13 Cuckmere Way

BH2021/04303

Brighton & Hove
City Council

- Hip to gable roof alteration
- Installation of a rear dormer
- Addition of four front rooflights
- The erection of a front porch with associated alterations

Proposed Front Elevation

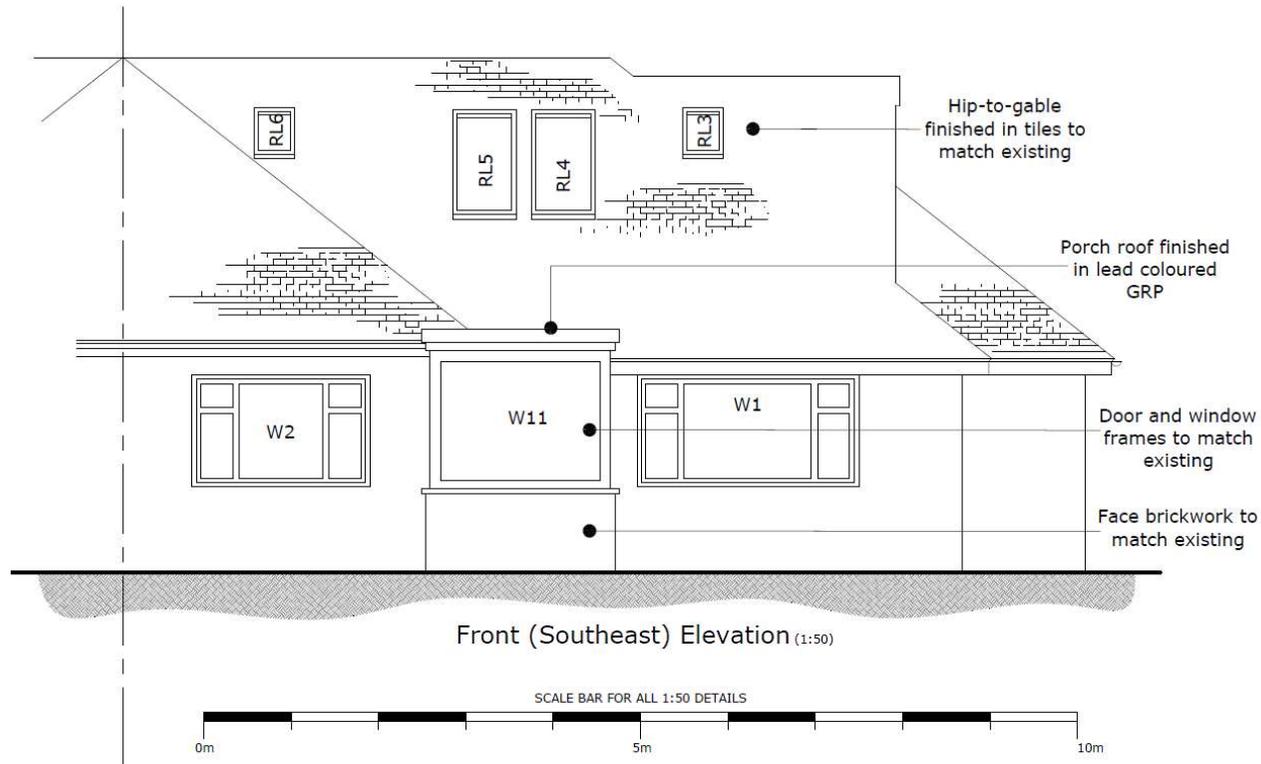
- Hip to gable and rear dormer not considered acceptable as would be inappropriate for the host building and surrounding area.
- Would create an 'L-shaped' wraparound dormer that would dominate the roofslope and unbalance the semi-detached pair.
- Rooflights and front porch unlikely to cause harm.
- Impact on amenity considered worse than existing arrangement
